Decision Date: April 25, 2019

Re: TT-74950-CN
Related Case: None
Site Addresses: 11614 – 11616 W. Burbank
Boulevard
Plan Area: North Hollywood-Valley Village
Specific Plan: None
Zone : [Q]R3-1
D.M. : 174-B-169
C.D. : 2
CEQA: ENV-2018-1763-CE
Legal Description: Lot: FR LT A (Arb 1,2,3)
and FR LT B (Arb 2,3)
Tract: 325

LOS ANGELES DEPT. OF CITY PLANNING
SUBMITTED FOR FILING
☒ TENTATIVE MAP

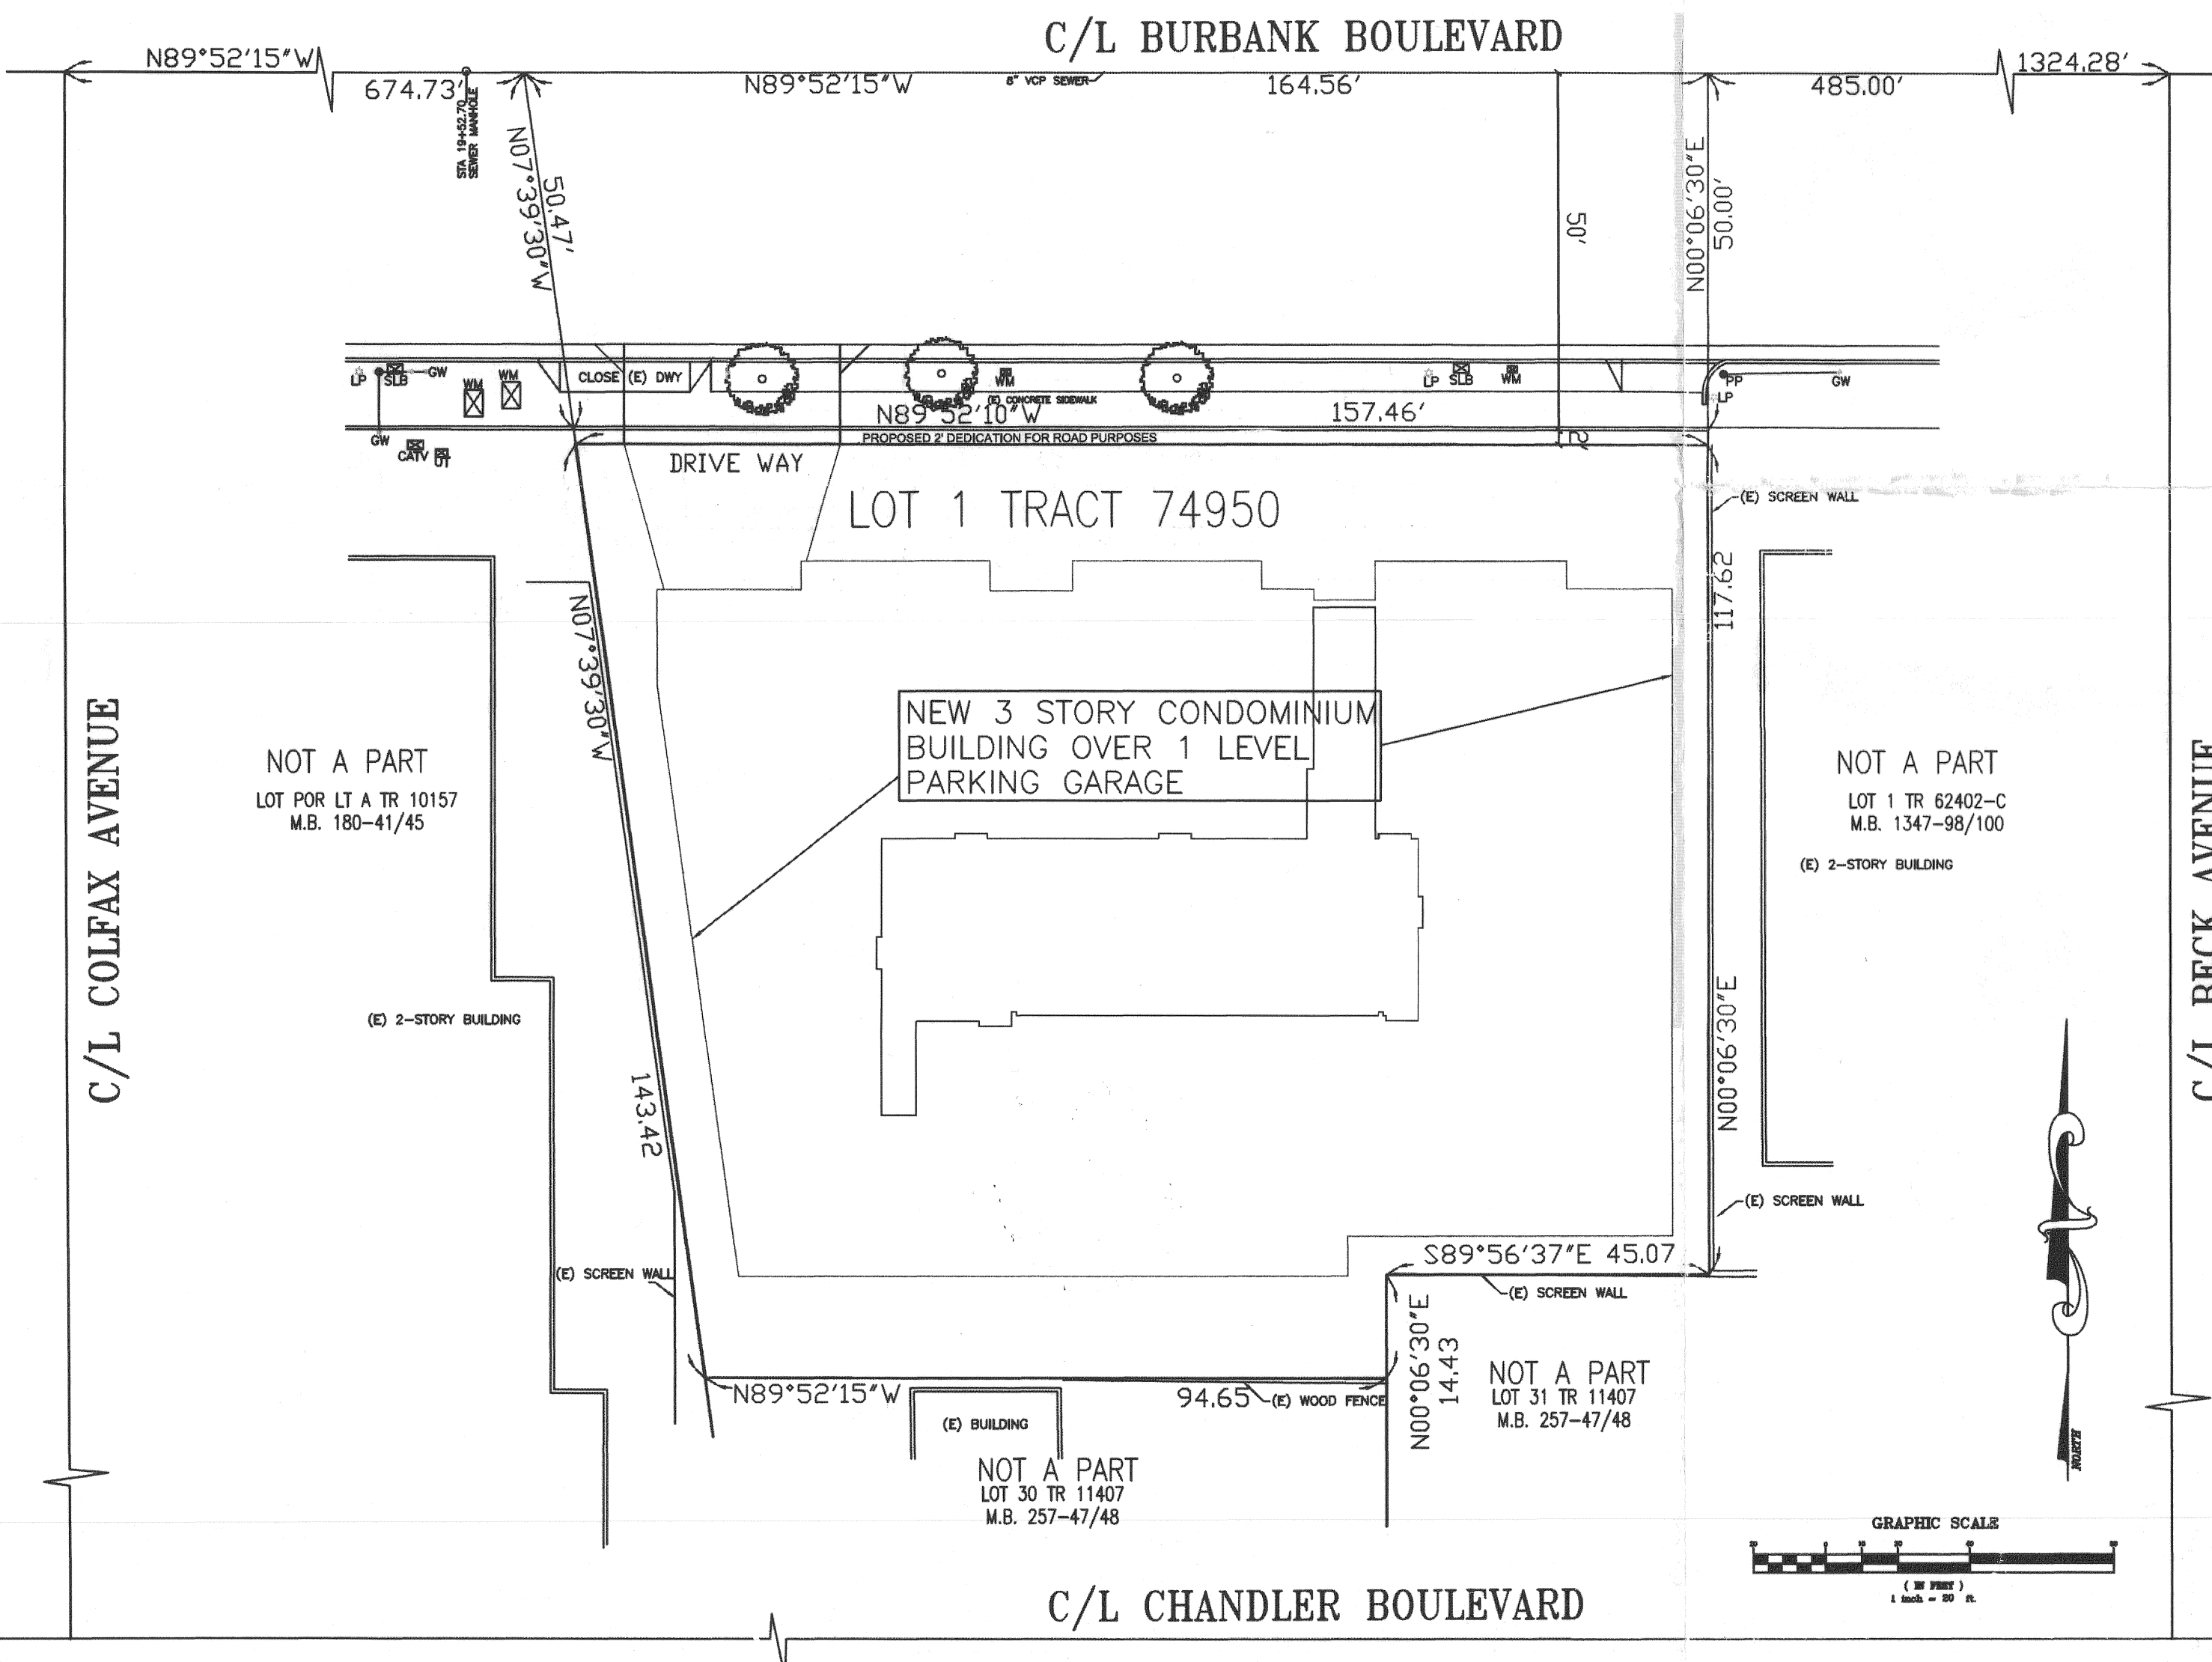
- b. The submitted Map dimensions do not agree with ZIMAS. Revise the Map to address the discrepancy or obtain approval from Department of City Planning.

- d. The submitted Map does not comply with the maximum density (1200 s.f. of lot area/dwelling unit) requirement of the [Q]R3-1 Zone. Revise the Map

The submitted Map may not comply with the number of parking spaces required by Los Angeles Municipal Code (LAMC) Section 12.21 A.4 (a) based on number of habitable rooms in each unit. If there are insufficient numbers of parking spaces, obtain approval from the Department of City Planning.

The submitted Map may not comply with the number of guest parking spaces required by the Advisory Agency.

to show compliance with the above requirement(s) or obtain approval from the Department of City Planning.
